RE: Central Coast - draft amendment LPS2022003 and permit DA2022107 -Subject:

# TASMANIAN PLANNING COMMISSION DIRECTIONS Draft amendment LPS2022003 and Permit DA2022107

# RESPONSE TO COMMISSION DIRECTIONS - 6 JOHNSONS BEACH ROAD, PENGUIN

**Figure 1: Distance from Sewage Pump Station**

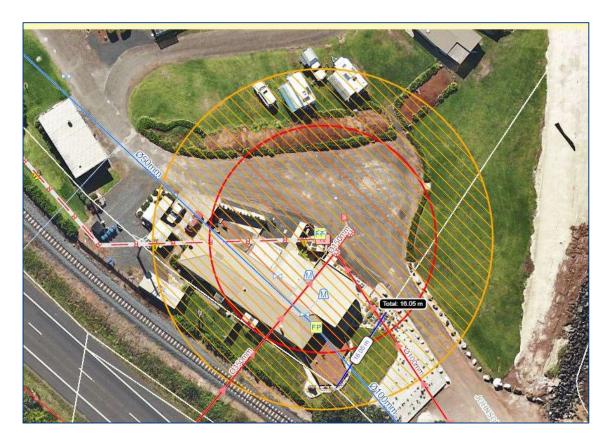
A distance of thirty metres from the SPS is shown in Figure 1 below (yellow circle). The proposed residence is virtually fully contained within this 30 metre circle.

One recommendation is to replace or repair of all three manhole lids near the SPS to ensure the sewage gases are contained within the sewerage system, and not able to vent at this location. This means that gases will likely vent at the Dial Point SPS where there are no sensitive receptors to be exposed to the odour.
